Responses to Interrogatories

Algoma Power Inc.
EB-2024-0007

Ref 2: Distribution System Plan part 1, Figure 2.12, p.55

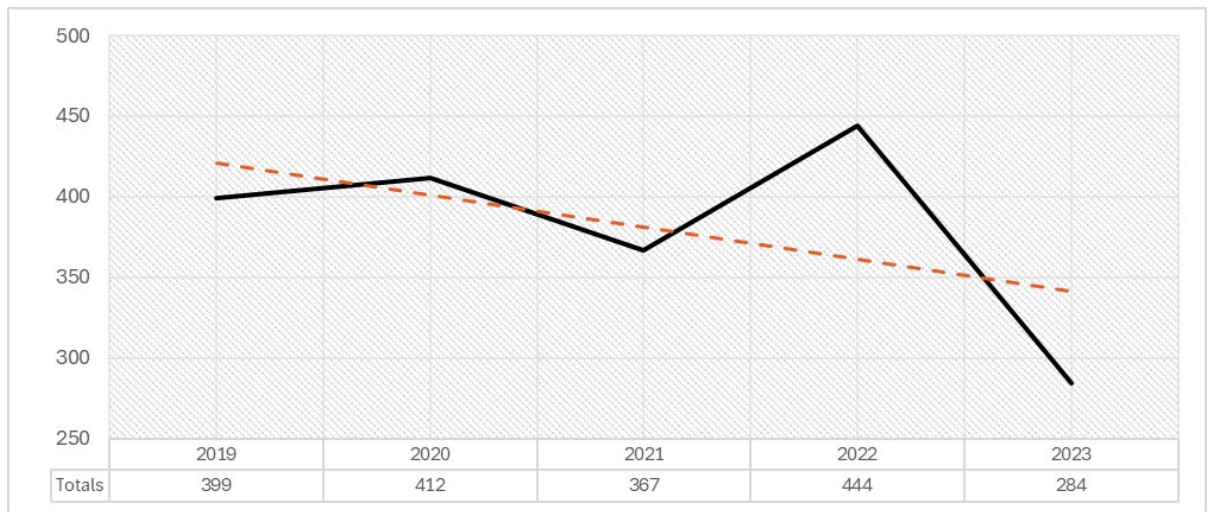
Figure 2.12 in reference 1 shows an increasing trend in number of outages per year excluding MEDs but including 1-Scheduled Outage, 2-Loss of Supply, and 9-Foreign Interference.

- a) What is causing the increasing frequency of outages caused by 0 - Unknown/Other, 1 - Scheduled Outage and 9 - Foreign Interference?
- b) What is causing the decreasing frequency of outages caused by 3 – Tree Contacts?
- c) Please restate Figure 2.12 in reference 2 after removing 1-Scheduled Outage, 2-Loss of Supply, and 9-Foreign Interference.

- a) Algoma Power has not completed a detailed outage cause investigation to determine likely cause of the outages that are assigned unknown/other cause code. API will monitor this trend going forward and will investigate further if warranted. Generally, this cause code is used when there was no evidence of what may have caused an outage. After the responding crew arrives on site, they perform a patrol in an attempt to find the fault cause. In some instances, however, a patrol is completed, and no clear evidence of the cause is found.

- b) The decreasing frequency of tree-contact related outage can be attributed to the efforts under Algoma Power Vegetation Management program over the last 15-20 years and to a smaller extent Algoma Power's line rebuild program as is explained in 2-Staff-10.
- c) The reinstated Figure 2.12 after removing 1-Scheduled Outage, 2-Loss of Supply, and 9-Foreign Interference is included below:
